PowerHook Rear Target Update Kit

Poweramp PowerHook restraints changed the design of the rear prox switch target beginning 9/1/2009. For units prior to this change, the 7056-0002 update kit must be installed to use a current guide track.

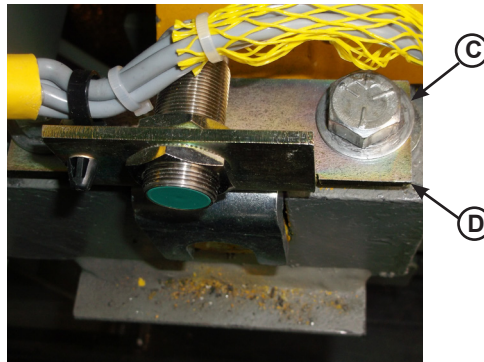
Step 1. Unplug harness & remove guide track.

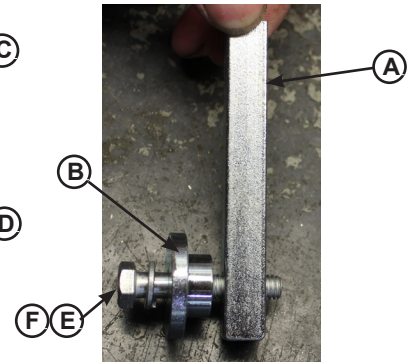
Step 2. Mount the rear prox bracket and new gland keepers (both sides).

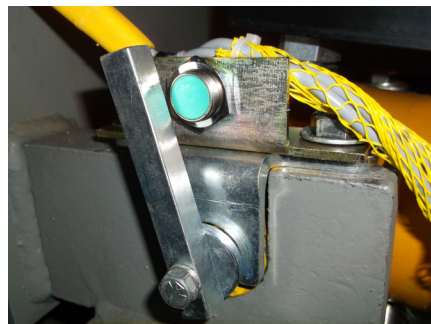
Step 3. Mount the rear prox target using new bolt and washer.

Step 4. Start adjustment at 10 o'clock position. Rotate **clockwise** to raise hook or **counter-clockwise** to lower. When adjustments are complete, top of hook should be 6" to 8" off the apron at full extension. See PowerHook Owner's/User's Manual for more detailed adjustment instructions.
